### TN\_161

# FT4222H Errata Technical Note

**Version 1.6**

**Issue Date: 12-10-2023**

**Figure 3.2 Quad SPI without Multi Write Phase**

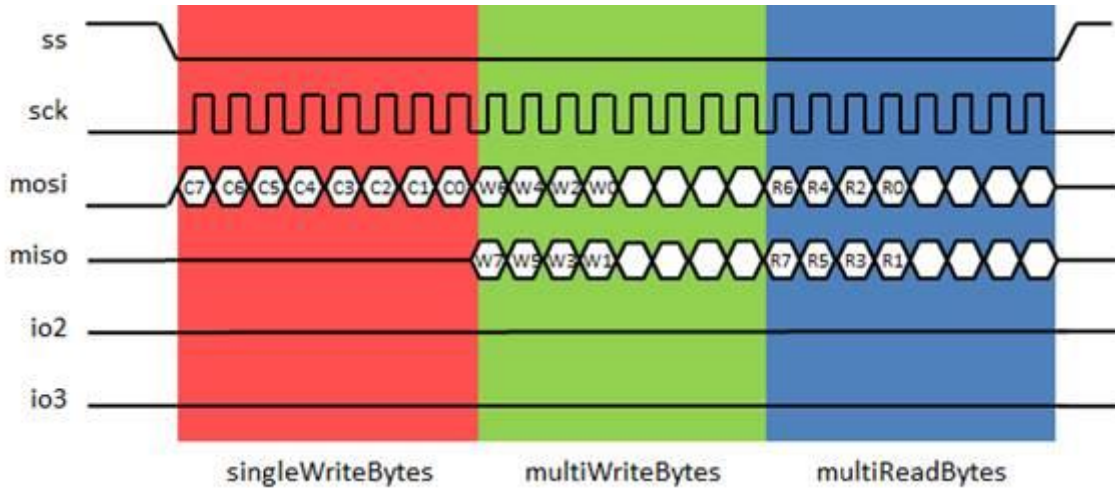
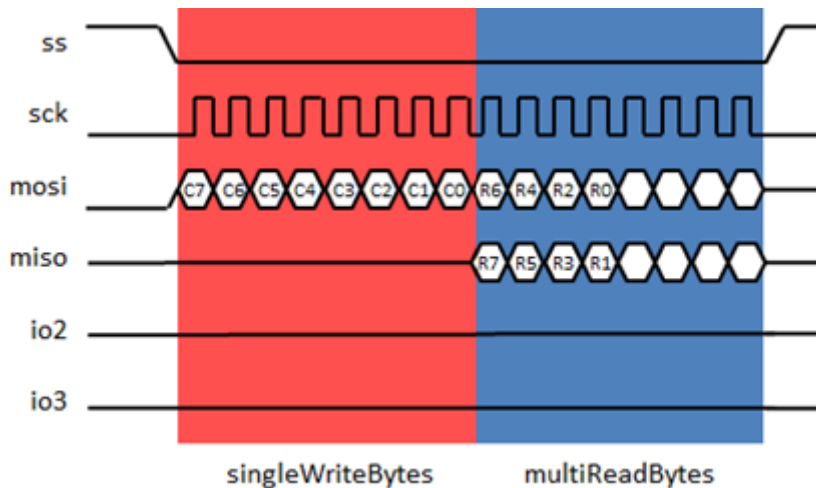
When accessing Toshiba flash with SPI Master Quad mode, FT4222H will hang without giving any responses.

Write Phase has no information/data to transfer. This combination of operating mode is not supported with Revision A, B, and C.

In SPI Master Quad mode, the operation of single write with quad read was not supported. No workaround was provided, this feature is implemented with Revision D.

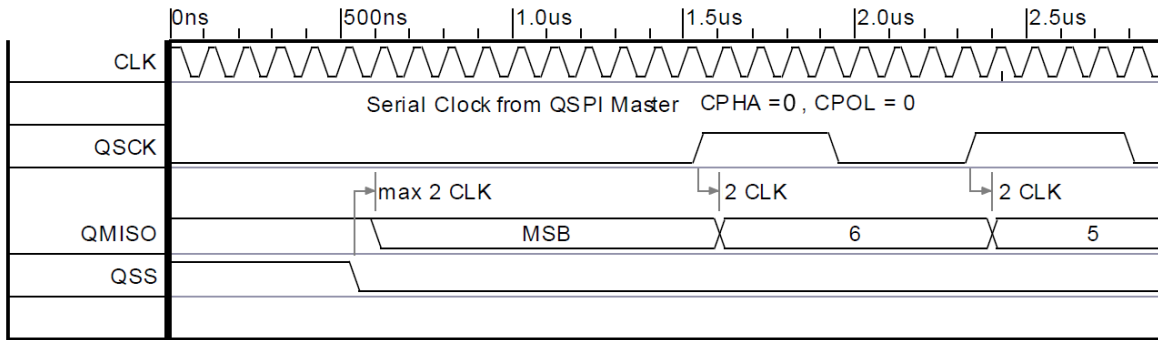
1. The first data bit is outputted immediately when CS activates.
2. The MISO changes IO polarity on trailing phase to make sure the data can be got the correct data on leading phase.

The issue happens on item 2.

As shown in the diagram below, FT4222 changes the IO polarity after 2 CLK (25ns) after leading phase happens. This issue may not cause problem when SPI Master is a hardware decode IP. However, if the SPI Master is a MCU base design with low sampling rate, the master might retrieve the wrong data.

Currently, there is no workaround for this issue. When leading phase happens, the SPI master needs to retrieve data as soon as possible. If the process cannot finish in 25ns, the data will be overwritten by the next data bit.
